Ordinary Council Meeting

Thursday, 29 September 2022

**Proposed Structure Plan - Lot 1221 Lakes Road and Lot 1400 Paterson Road, Nambeelup
Schedule of Modifications**

Proposed Structure Plan – Lot 1221 Lakes Road and Lot 1400 Paterson Road, Nambeelup

Figure 2: Nambeelup Industrial District Structure Plan

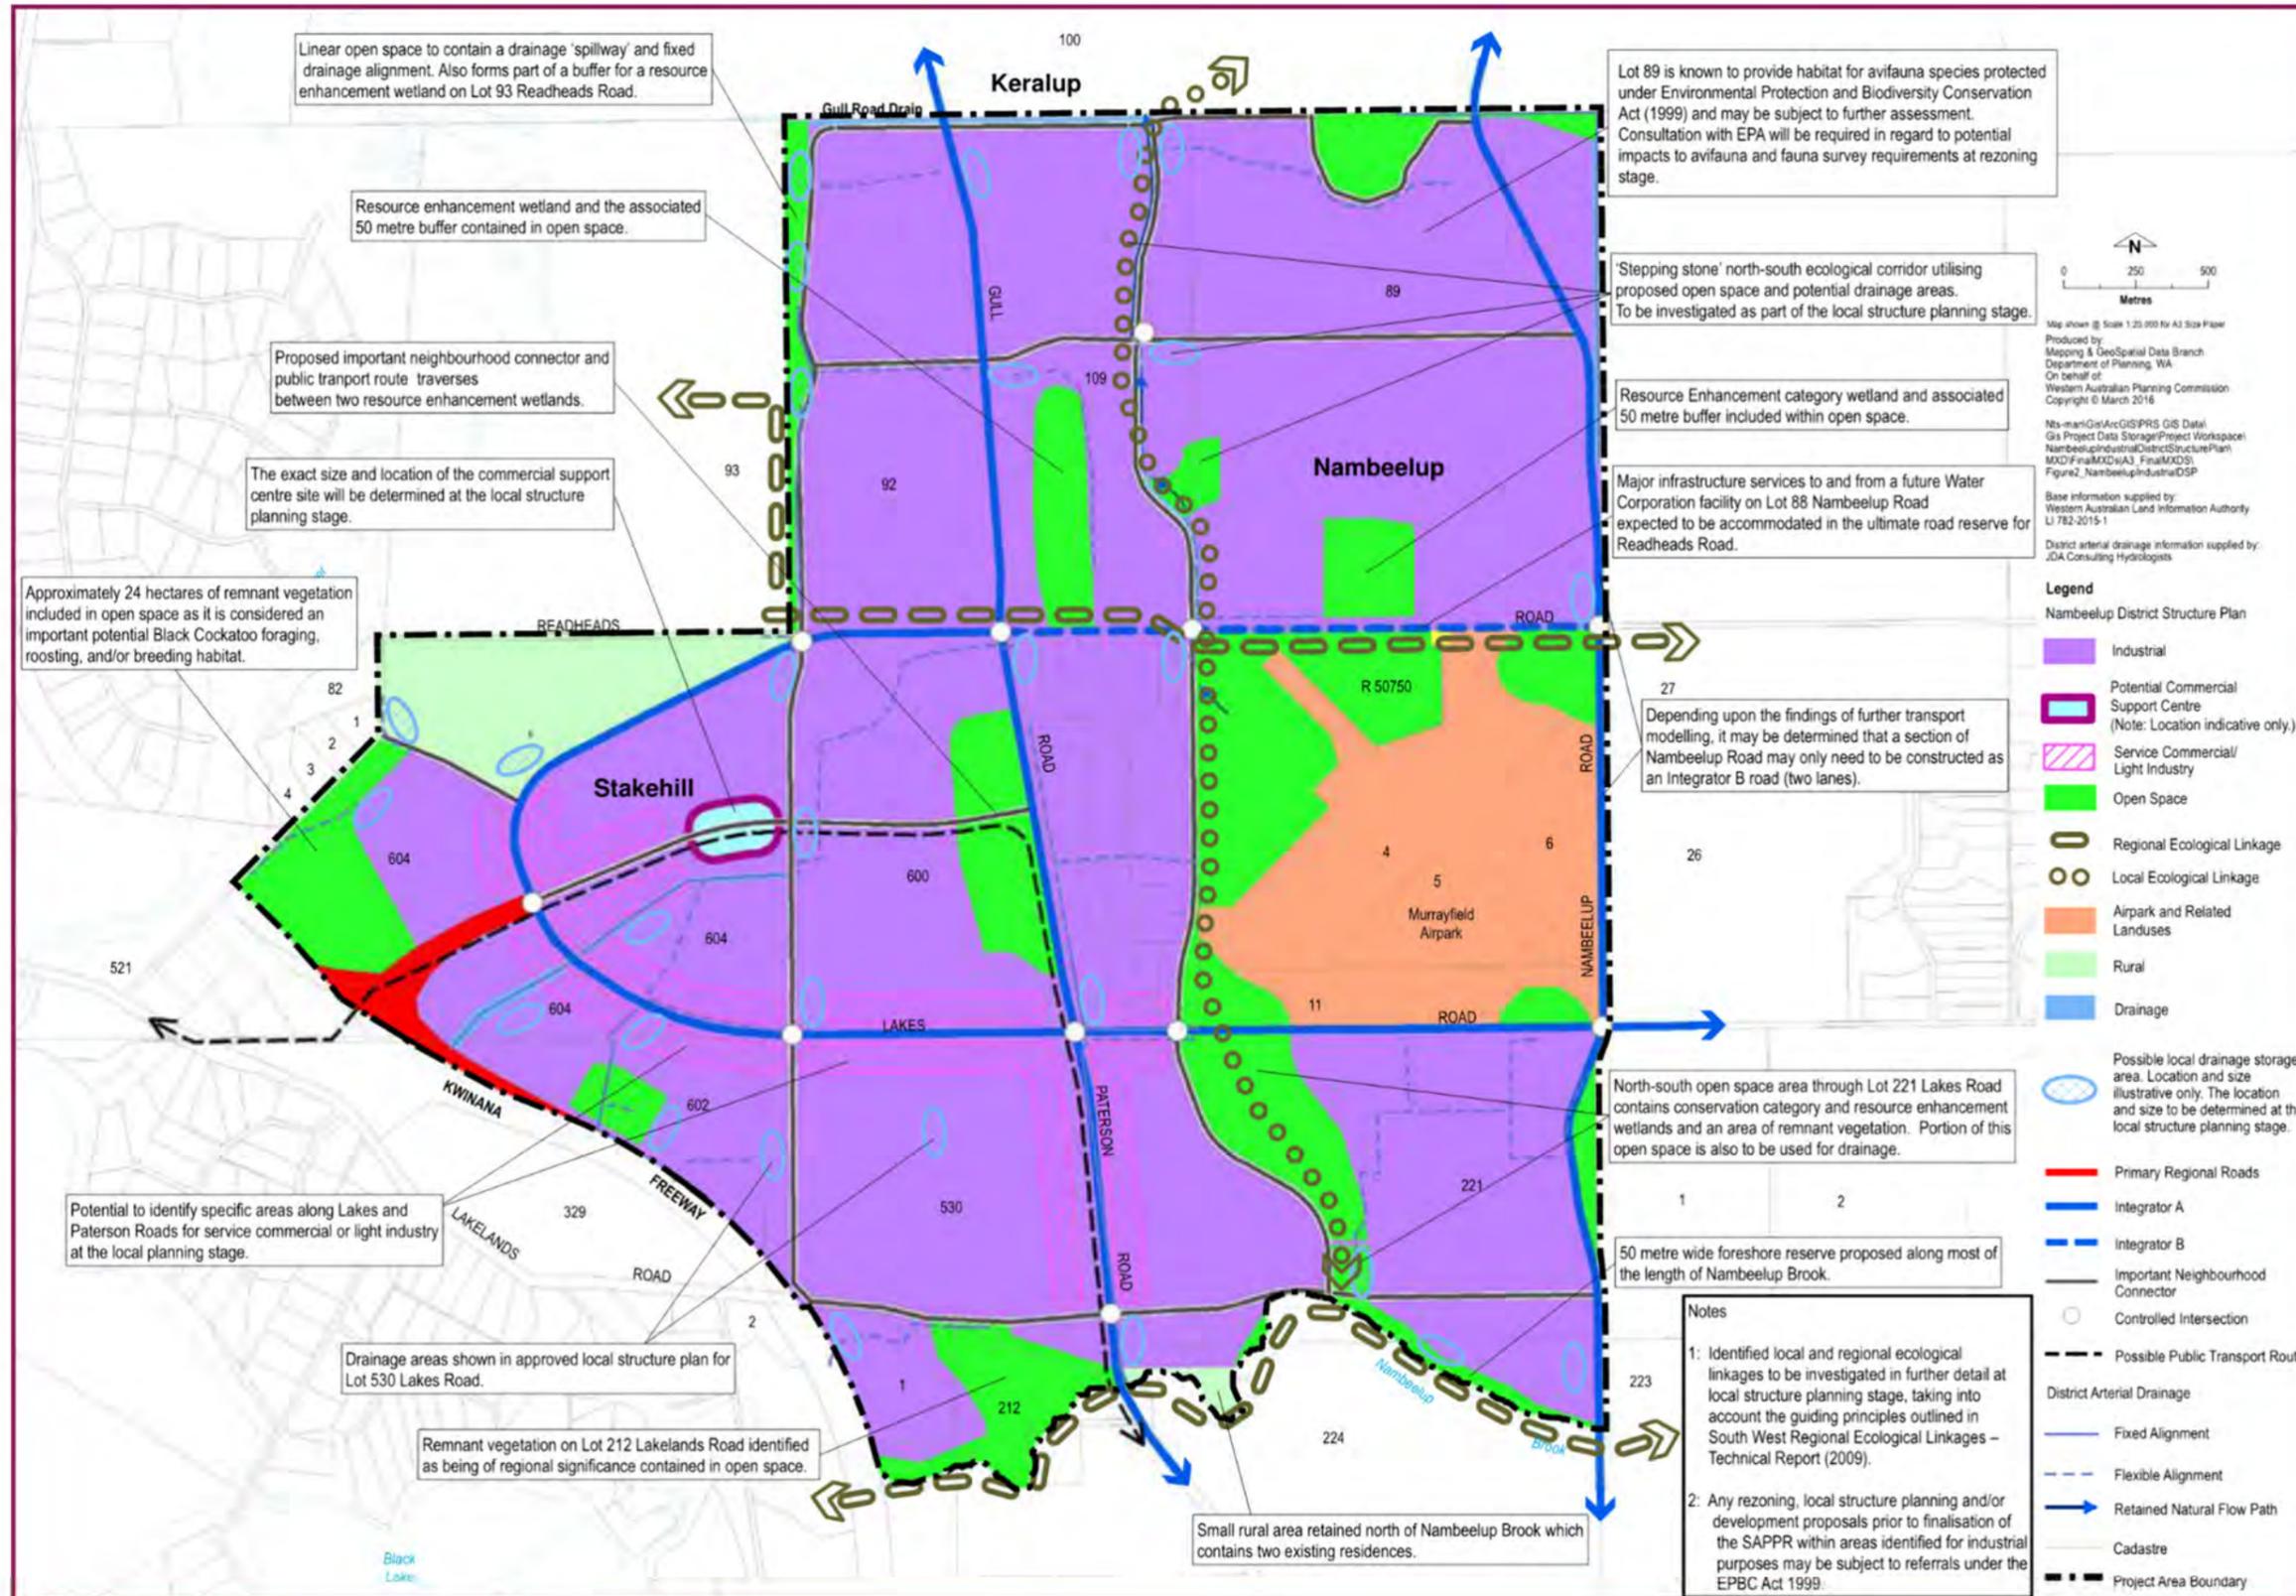
3.5.2 - Proposed Transport Network	<p>The closing paragraph on p28 states key aspects of the road network which do not align with the Nambeelup Industrial Area District Structure Plan (DSP).</p> <p>The DSP district structure plan proposed the following road hierarchy:</p> <ul style="list-style-type: none"> • Lakes Road - Integrator A, 60 metre road reservation width/ dual divided carriageway of 10 metre pavement/ central median 10metre wide for open drain within the reserve 10metres • Paterson Road – Integrator A 39-42 metre road reservation width/ dual divided carriageway of 10 metre pavement/ open drain within the reserve 10metres • Nambeelup Road– Integrator A 39-42 metre road reservation width/ dual divided carriageway of 10 metre pavement/ open drain within the reserve 10metres <p>P28 be amended to ensure at subdivision the ultimate road reserve be created</p> <ul style="list-style-type: none"> • Lakes Road will be staged to achieve ultimate Integrator A standard in accordance with the DSP. Key intersection treatments to be constructed at stage 1 of subdivision to manage traffic circulation and safety. The ultimate road reserve is to be created at stage 1 of subdivision and fully earth worked and filled to subgrade level.
